PLANNING AND ZONING CASE CHECKLIST

Project Number: SP2018-013
Project Name: Village Green Residence at Rockwall
Project Type: SITE PLAN
Applicant Name: DL MARKETPLACE PARTNERS, INC
Owner Name: CAMERON, & CAMERON
Project Description:

SP2018-013 - VILLAGE GREEN RESIDENCE AT ROCKWALL
SITE PLAN - LOCATION MAP =

Re: Village Green Residence at Rockwall Resubmittal
Re-submittal #1 – Site Plan (SP2018-013)

EAST EXTERIOR ELEVATION SCALE: 1/8" = 1'-0" 01

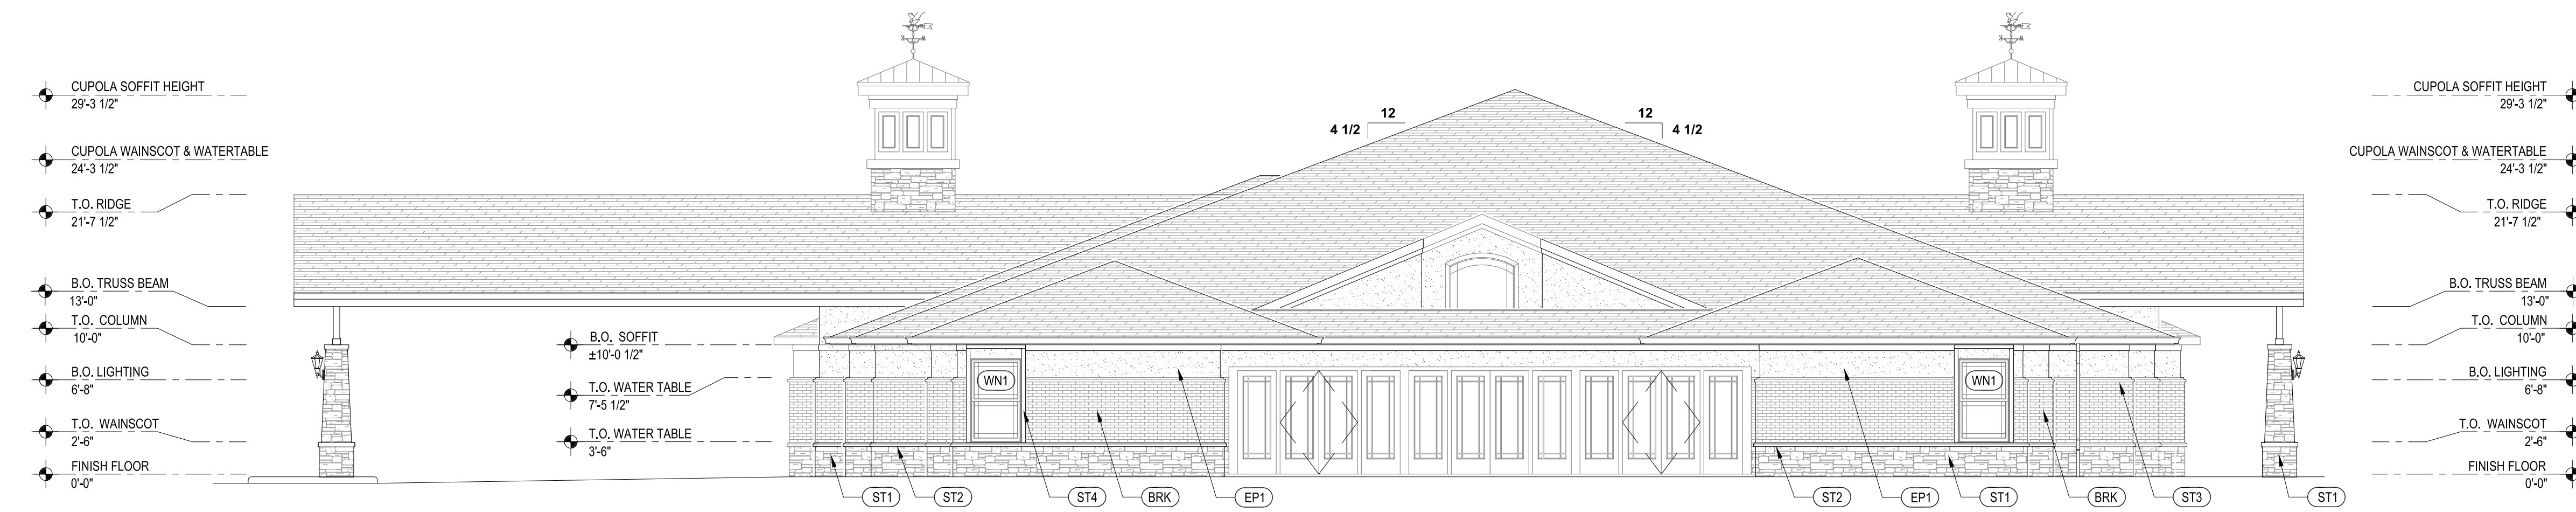
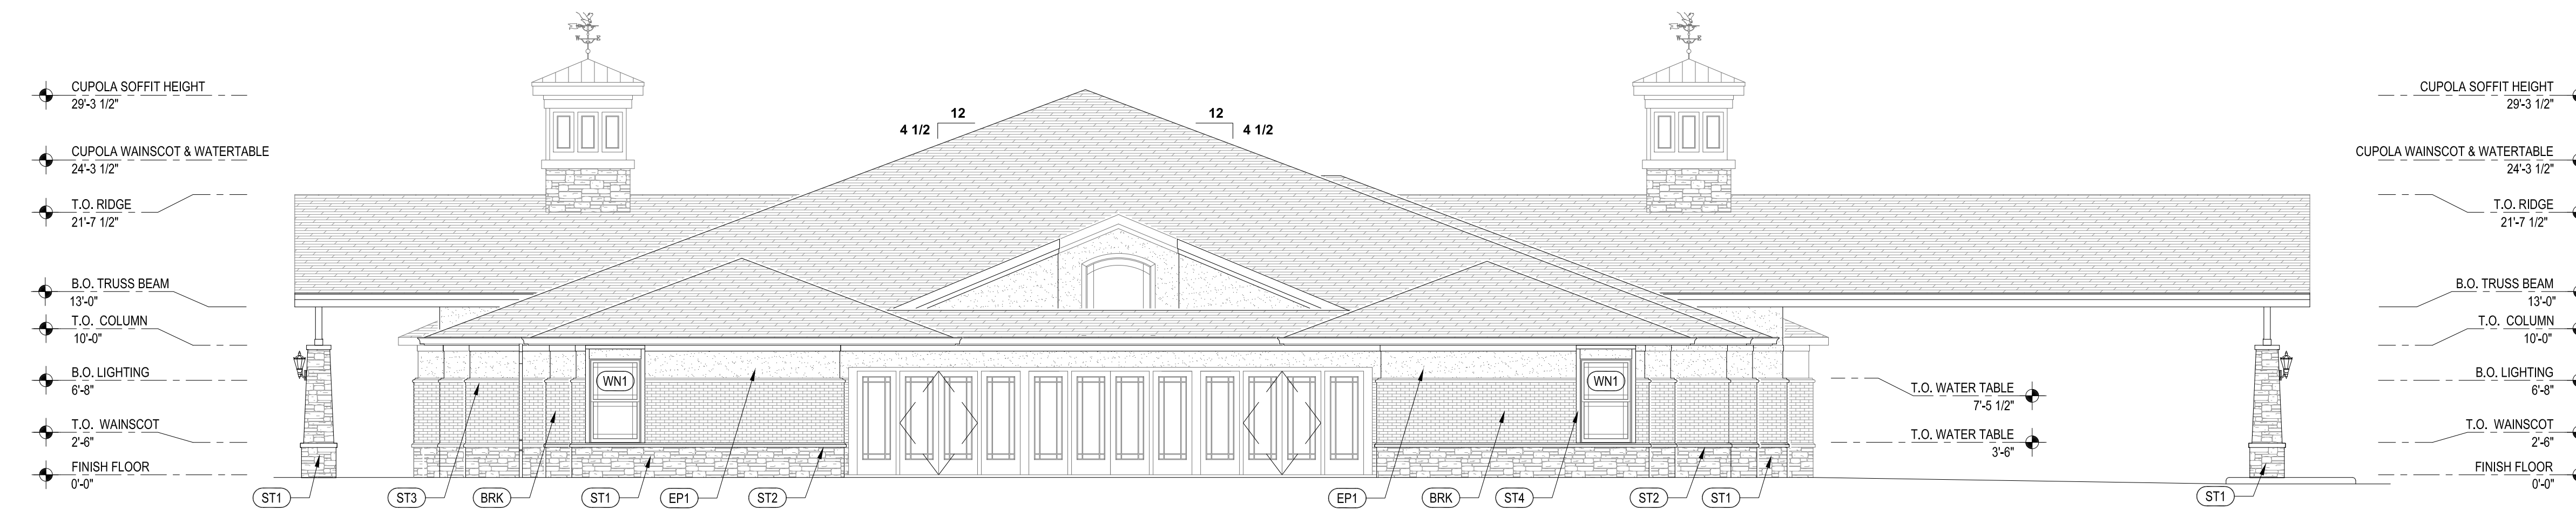
1. Requires a recommendation from the Architectural Review Board(ARB) forwarded to the Planning and Zoning Commission for consideration						
2. Stucco [Key EP1]. Is the material a 3 part stucco system or is this EIFS?

3. Provide a materials sample board for ARB review.						
Open Space Master Plan:						
1. To be considered by the Parks Board on June5, 2018 with their recommendation forwarded to the City Council for approval

SHEET NUMBER:
 L2 of 3

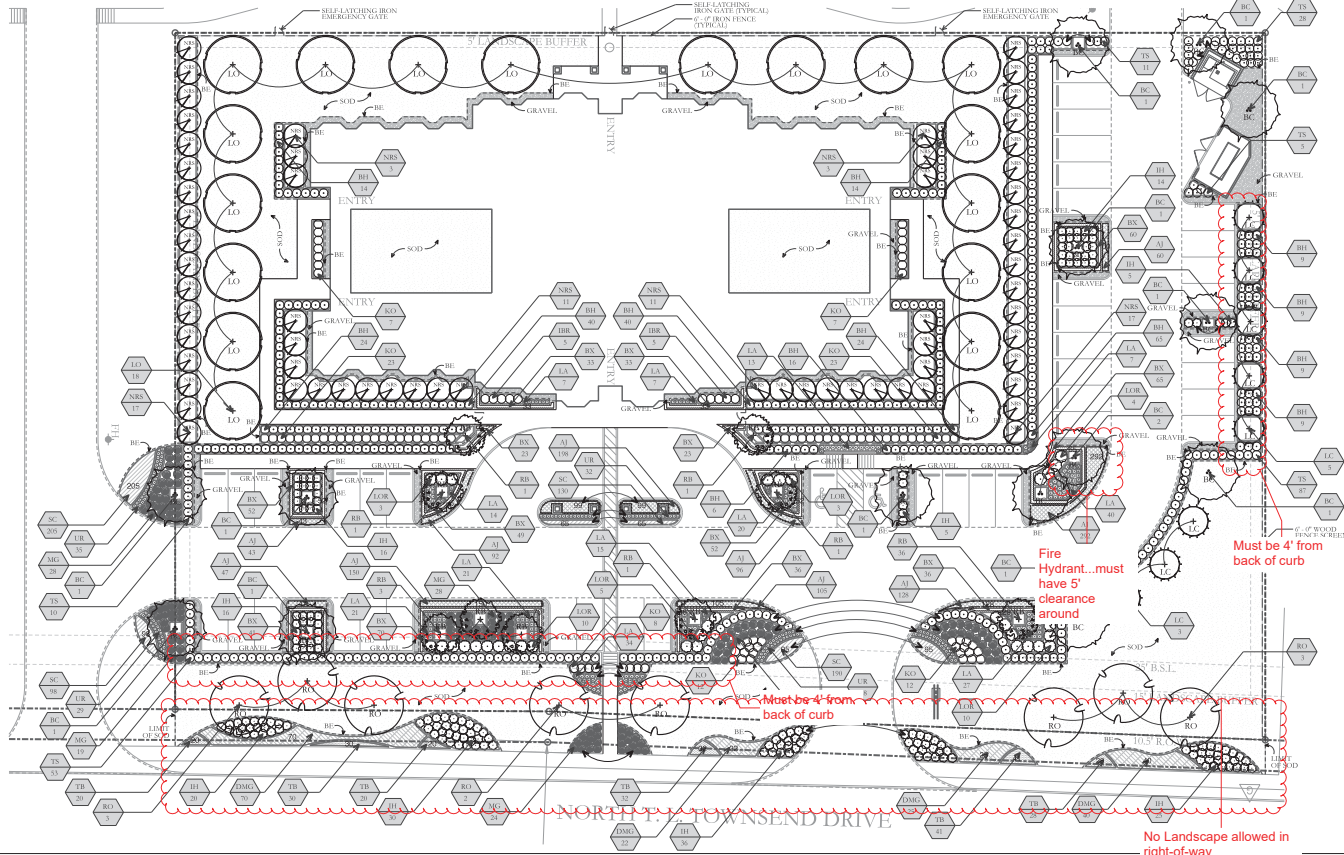
-All plantings/shrubs must be planted 4' from back of curb for all 18' parking spaces
 - No trees to be planted within 5' of any utility (Add note to plans)
 - No landscaping in the public right-of-way as well as irrigation
 - Not showing fire hydrant. All planting must be 5' away from fire hydrants
